Access Compliance Report

Public Rights-of-Way

(Curb Ramps)

Intersection ID: 9330	Main Street: FRANKLIN_AV	Cross Street: RACHEL_ST	Location:	E
ADA ID: C1B8C896F500	Ramp Type: Para	Initial Pass/Fail: Fail	Overall Compliance: No	Severity Score: 25
Codes/Mitigation Info/Possible Solution		Field Measurements/Component Compliance

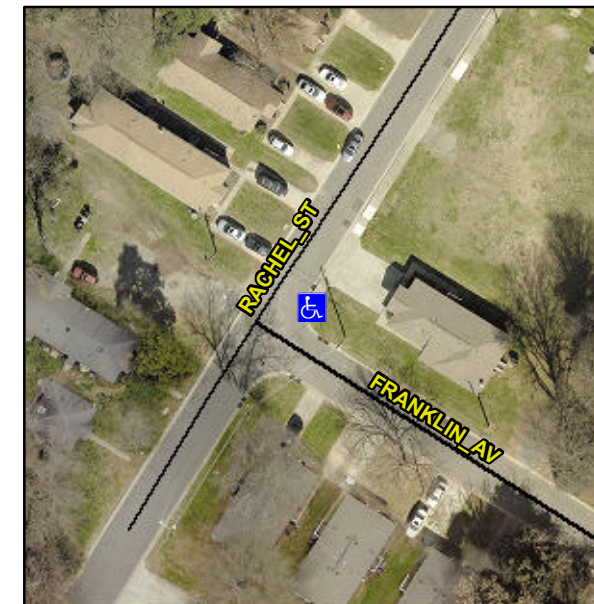
CURB GAP 1.5

R304.3.2

Compliance	Description	Data	Compliance	Description	Data
N/A	Ramp Length LT (in)	58.0	N/A	Ramp Length RT (in)	54.5
Yes	Ramp Width LT (in)	60.0	Yes	Ramp Width RT (in)	59.0
Yes	Ramp Slope LT (%)	6.0	No	Ramp Slope RT (%)	12.8
Yes	Ramp XSlope LT (%)	1.7	Yes	Ramp XSlope RT (%)	2.0
N/A	Landing Length (in)	N/A	N/A	DWS Provided?	N/A
N/A	Landing Width (in)	N/A	N/A	DWS Contrast?	N/A
N/A	Landing Slope (%)	N/A	N/A	DWS Length (in)	N/A
N/A	Landing X Slope (%)	N/A	N/A	DWS Full Width?	N/A
N/A	Landing Curb? (Y/N)	N/A	N/A	DWS Offset (in)	N/A
N/A	Shared Landing?	N/A			
N/A	Gutter Ponding?	N/A	N/A	Gutter Slope (%)	N/A
N/A	Gutter Lip Ht (in)	N/A	N/A	Gutter X Slope (%)	N/A
N/A	Painted X Walk1?	No	N/A	Painted X Walk2?	N/A
	X Walk 1 Direction	To SW		X Walk 2 Direction	N/A
N/A	X Walk 1 Width (in)	N/A	N/A	X Walk 2 Width (in)	N/A
	X Walk 1 Slope (%)	4.7		X Walk 2 Slope (%)	N/A
	X Walk 1 X Slope (%)	1.1		X Walk 2 X Slope (%)	N/A
N/A	Ramp inside XWalk1?	N/A	N/A	Ramp inside XWalk2?	N/A

Remove & Replace Entire Ramp.
